Technical Service Bulletin: TSB210184	Released Date: 25-Aug-2021
Remote Mount Fuel Line Replacement Procedure: External Fuel Leaks, Fault Codes 559 and 4691

- L9 CM2350 L133C
- L9 CM2450 L126B

Figure 1, Example Locations of the Remote Mount Stage 2 Fuel Filter.

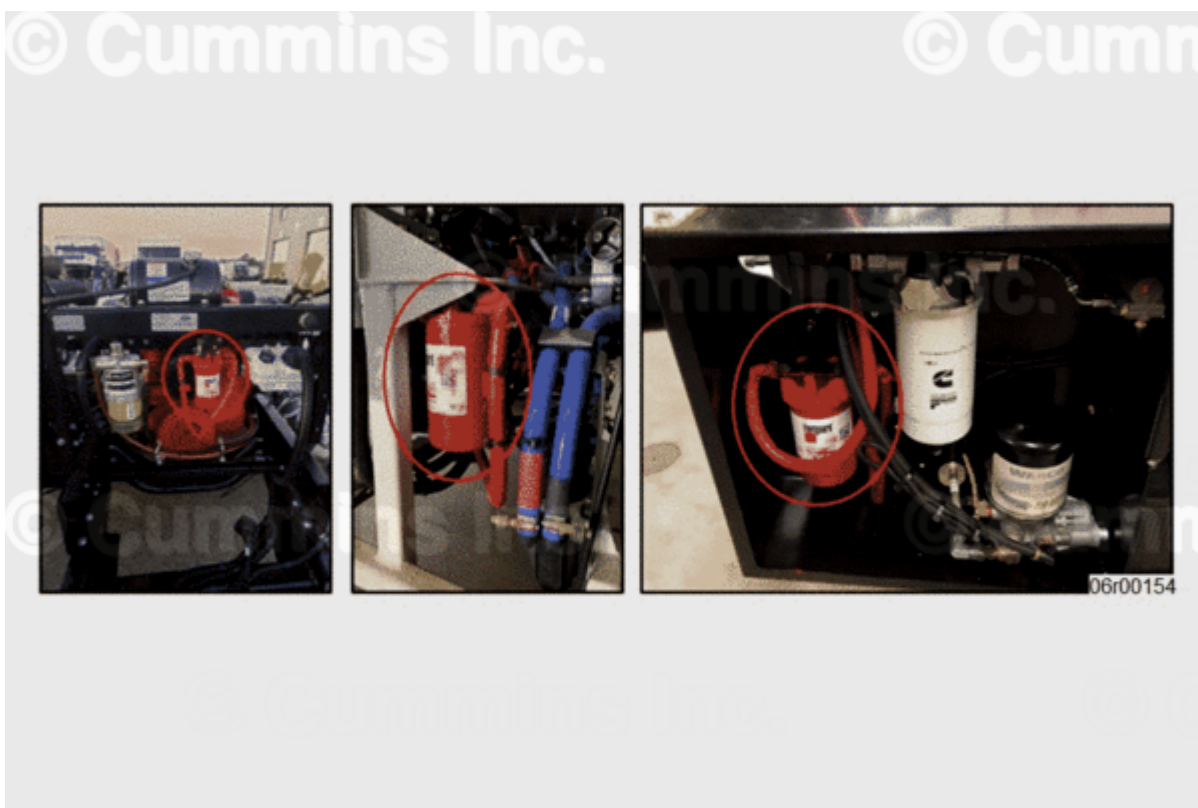
This issue is **only** for remote mount stage 2 fuel filter to fuel pump supply and return fuel lines. The remote mount stage 2 fuel filter is mounted off-engine. The mounting location for the fuel filter head assembly varies depending on vehicle type. Examples of possible mounting locations included in Figure 1 below.

Figure 2, Indication of Fuel Pump Inlet and Fuel Filter Outlet Quick Connect Fitting Locations.

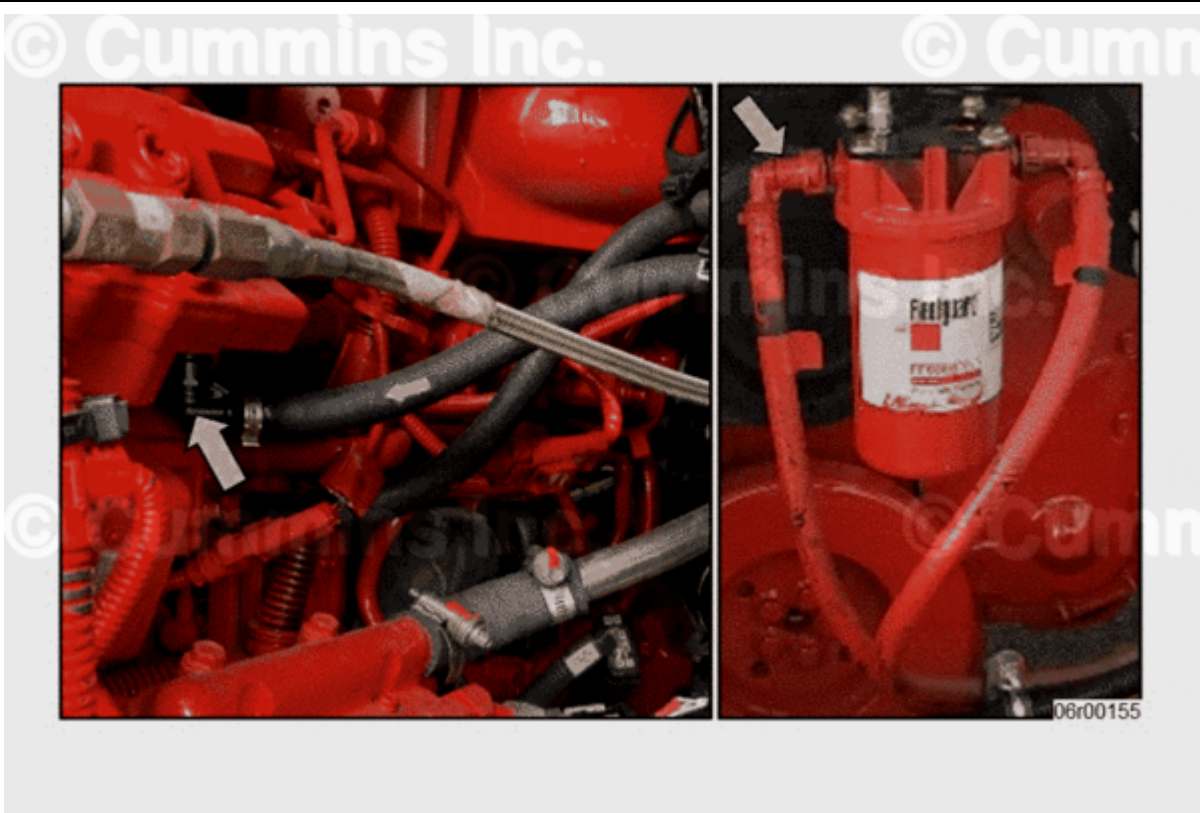
- One fuel line runs from the stage 2 fuel filter head quick connect fitting to the fuel pump inlet quick connect fitting.
- The second fuel line will run from the fuel pump outlet quick connect fitting to the stage 2 fuel filter head return quick connect fitting.
- Figure 2 below indicates the fuel filter head outlet and fuel pump inlet connection points.
- Figure 3 below indicates the fuel pump outlet and fuel filter head return connection points.
- Verify the fuel lines are routed correctly between the outlet of the filter head to the inlet of the pump and outlet of pump to the fuel filter head return or premature fuel pump wear can occur.
